SPACE-BASED POSITIONING
NAVIGATION & TIMING
NATIONAL ADVISORY BOARD

Subject: PNT Advisory Board (PNTAB) Recommendation to PNT Executive Committee (EXCOM) Regarding Latest Ligado Proposal

Analysis of
Ligado May 2018 Proposal
and Assessment
August 2018

Overview: Transmitter Power, Transmitter Tower Spacing and Percentage Degradation Area for GPS receivers

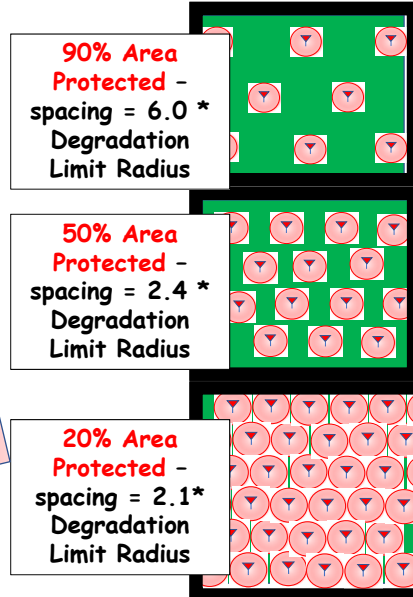
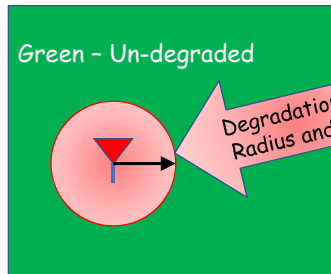
- Virtually all receivers will be degraded if they are too close to a Ligado Transmitter (overwhelm the "front-end")
- Consider a **hypothetical case**, where receivers can be degraded up to 10% of their operating area
 - Then **degradation radius** around each tower must be **less than 0.17 times the spacing** This is called the **Degradation Limit Radius**
 - This can be achieved by either **reducing power** or **increasing spacing** (decreasing tower density)
- Earlier Ligado proposal is that tower spacing should be ~400 meters.

Figure I-87: Small Cell Outdoor/Micro Urban (EIRP = 40 dBm),
Bounding HPR, 1530 MHz

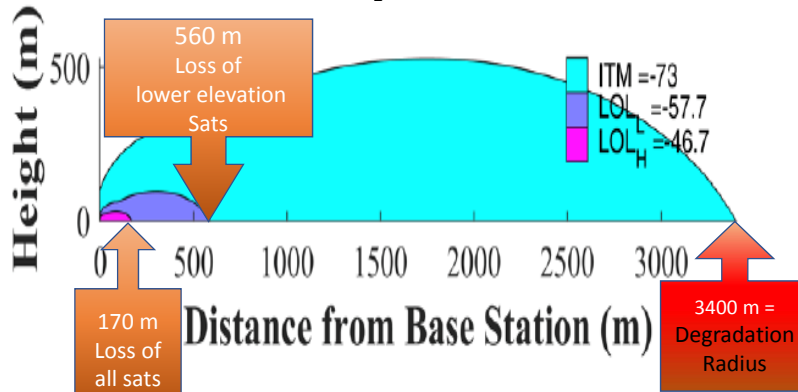
*From Appendix I -DOT Test and Analysis:
High Performance Receivers -
Impacts of single 10W Ligado micro-Urban transmitter.
* Degradation Radius is 3.4 Km.
* Start losing Low Elevation Satellites at 560m.
Start Losing All Satellites at 170m*

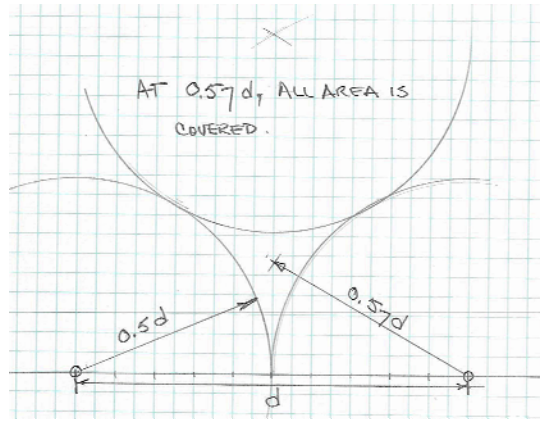
Max Ligado Transmitter Power and tower density should be constrained by the % area that is degraded

Geometric problem directly scales with spacing of transmitters (d)
 Furthest point from all is at $1/3^{0.5}$ times $d = 0.57 * d$

For Example:
 At $0.57 * d$, 100% of the area would be covered

What degradation radius would result, if degradation were limited to 10% of the area?
